**SUNDRY NOTICES AND REPORTS ON WELLS**  
*Do not use this form for proposals to drill or to re-enter an abandoned well. Use form 3160-3 (APD) for such proposals.*

8. Well Name and No.  
DALL FEDERAL 1

RKI Exploration & Production, LLC is requesting to Plug and Abandon this well.

**Proposed Plugged WBD**

**Dall Fed #1  
Proposed WB**

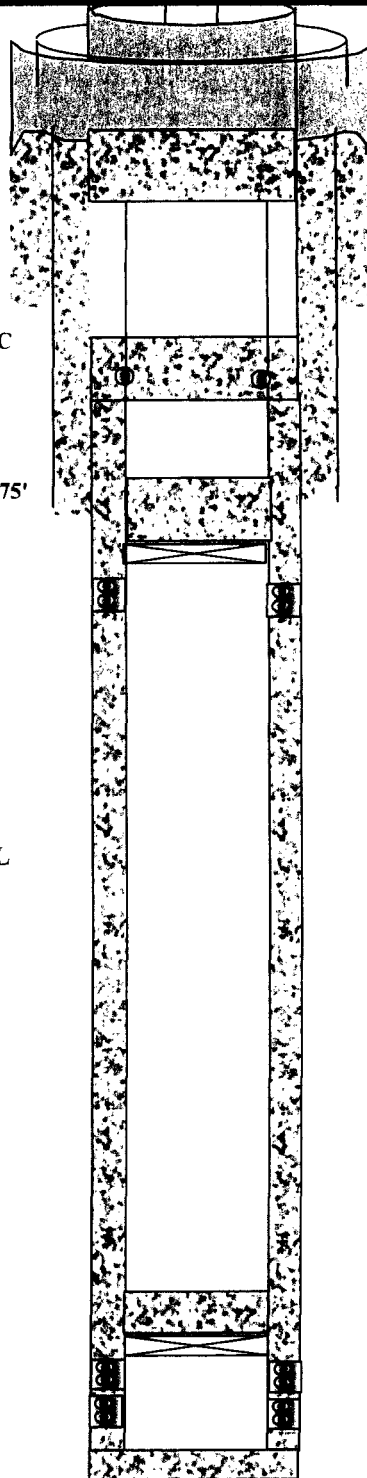
**\*\* BLM REVISED \*\* BLM REVISED \*\* BLM REVISED \*\* BLM REVISED \*\* BLM REVISED \*\***

*7/26/16 1680*

- 11) RIH w- tbg. to 150' 395 Perf and SQZ cmt to Surf,
- 12) Spot 25 sxs. cmt. to surface.
- 13) RDMO Service Unit. RDMO Cementers.
- 14) MIRU Welder. Cut-off casing head. WO cap with well name and number, operator name, and date.
